**Changes to the MANN+HUMMEL ProVent 200 / 2020-I-24****ProVent Conversion Kit: LC5001/2X**

We would like to inform you about an imminent design change of our ProVent 200 System. The new ProVent 200 will be known as the **ProVent 200 IV**. The 'IV' is in reference to the new 'internal ventilation' characteristics of this new design.

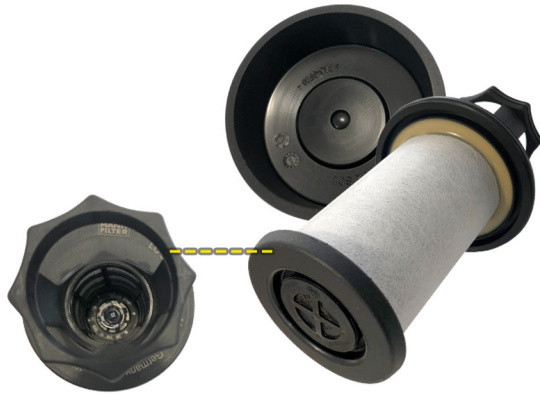
1. The new LC5001/2X element design with integrated over-pressurisation valve
2. Replacement O-ring for system lid
3. Replacement inner lid conversion kit
4. Simple system conversion instructions
5. Replacement ProVent 200 IV label

**2020: PROVENT 200 IV**

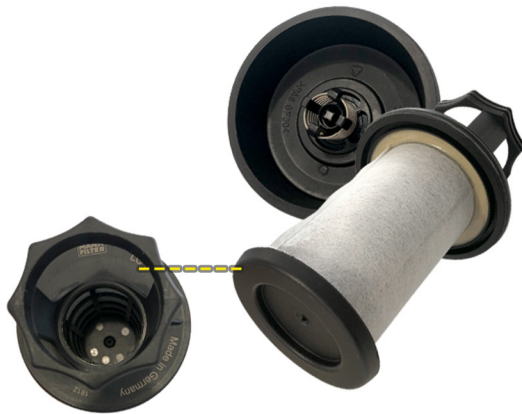
1. Inclusion of the new LC5001/2X element design which has an over pressurisation valve integrated into it.  
(Patents, designs, trademarks applied for)
2. Revised inner lid design which has the over pressurisation valve deleted.  
(Patents, designs, trademarks applied for)

**ProVent 200 IV Conversion Instructions.**

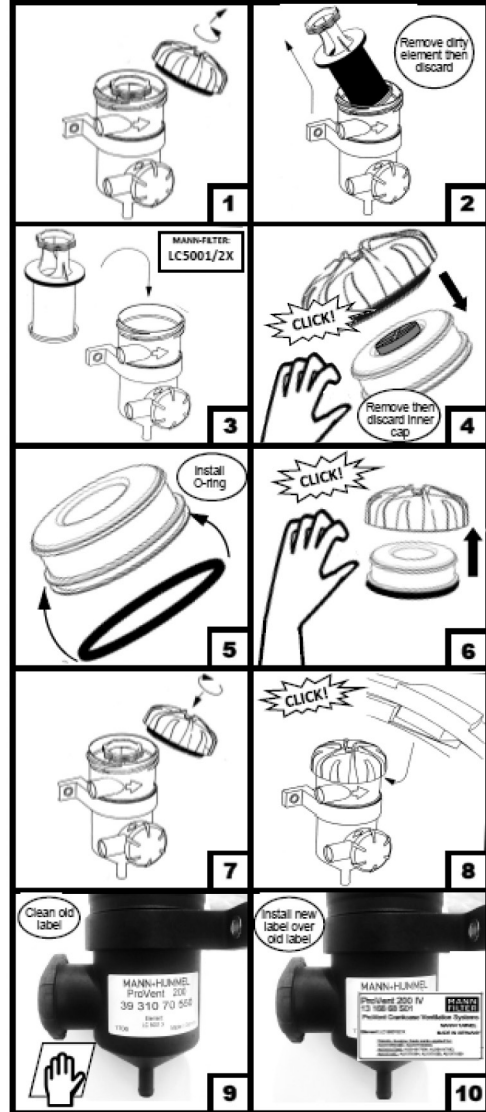
**WARNING:** Only install LC5001/2X after conversion completed.
